SOLICITATION AMENDMENT
MODIFICATION DE L'INVITATION

Title - Sujet CanNor Relocation & Renovation	
Solicitation No. - N° de l'invitation EZ899-160207/A	Amendment No. - N° modif. 001
Client Reference No. - N° de référence du client	Date 2015-06-24
GETS Reference No. - N° de référence de SEAG PW-\$PWY-019-7526	
File No. - N° de dossier PWY-5-38033 (019)	CCC No./N° CCC - FMS No./N° VME
Solicitation Closes - L'invitation prend fin at - à 02:00 PM on - le 2015-07-02	Time Zone Fuseau horaire Pacific Daylight Saving Time PDT
F.O.B. - F.A.B. Plant-Usine: <input type="checkbox"/> Destination: <input checked="" type="checkbox"/> Other-Autre: <input type="checkbox"/>	
Address Enquiries to: - Adresser toutes questions à: Ngan, Ken (PWY)	Buyer Id - Id de l'acheteur pwy019
Telephone No. - N° de téléphone (604) 658-2755 ()	FAX No. - N° de FAX (604) 775-6633
Destination - of Goods, Services, and Construction: Destination - des biens, services et construction: CanNor - Elijah Smith Building - Whitehorse, YT

Please find Addendum #1 attached.

CAN NOR Relocation Consolidated | Second Floor - Hoarding Revised

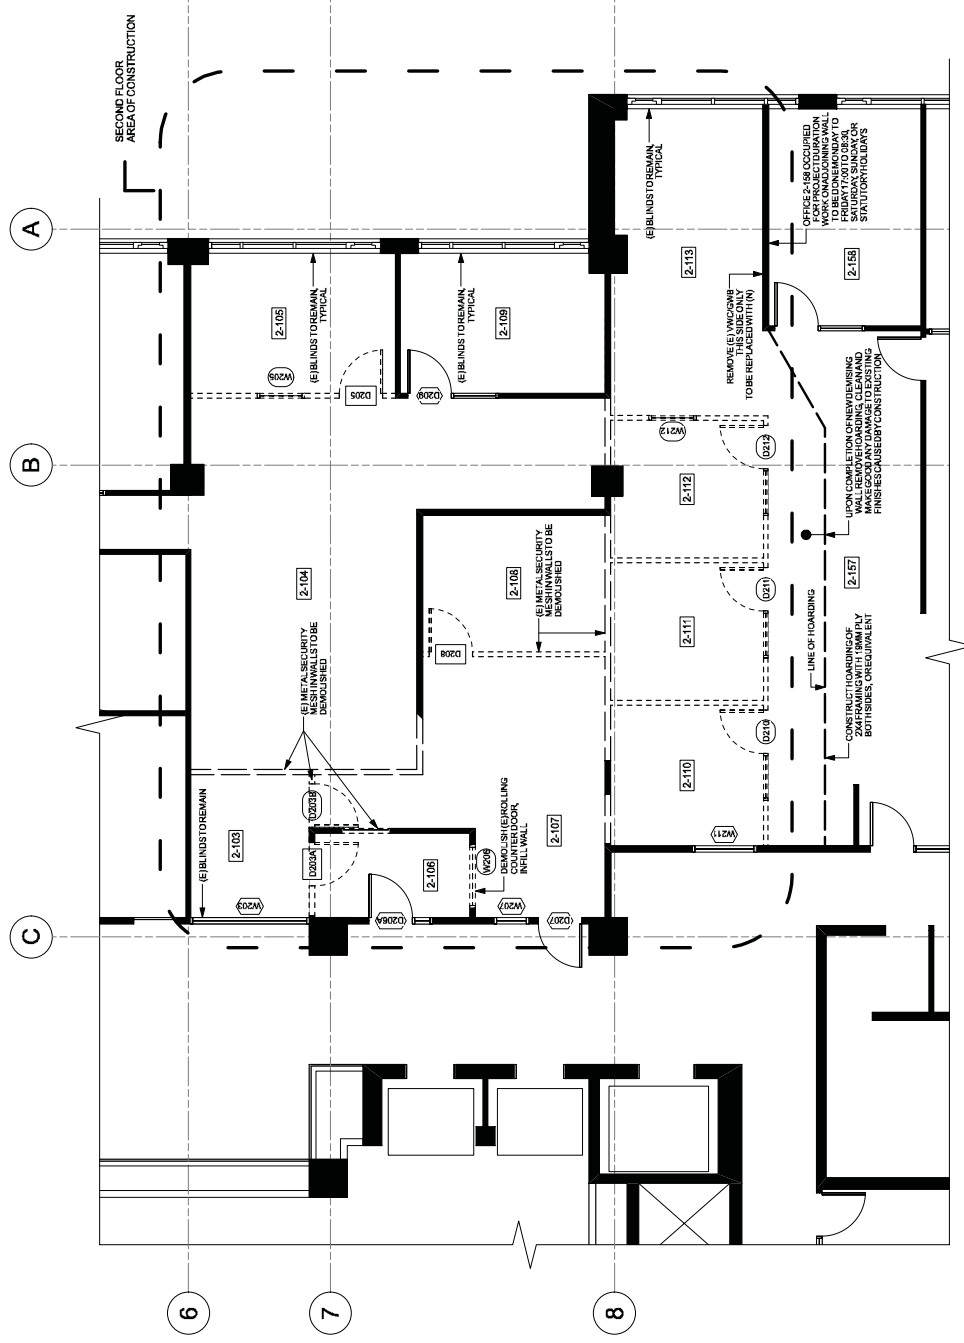
A01 Second Floor Demolition Plan

See SK-01, attached, for revisions.

DELETE Delete notes regarding Phase 1 and Phase 2 Demolition.

ADD Office 2-158 to be occupied for the duration of the project, work on wall adjoin 'Area of Construction' to be done Monday to Friday between 17:00 to 08:30, Saturdays, Sundays, and statutory holidays.

ADD Construction hoarding of 2x4 framing with 19mm plywood both sides, or equivalent.
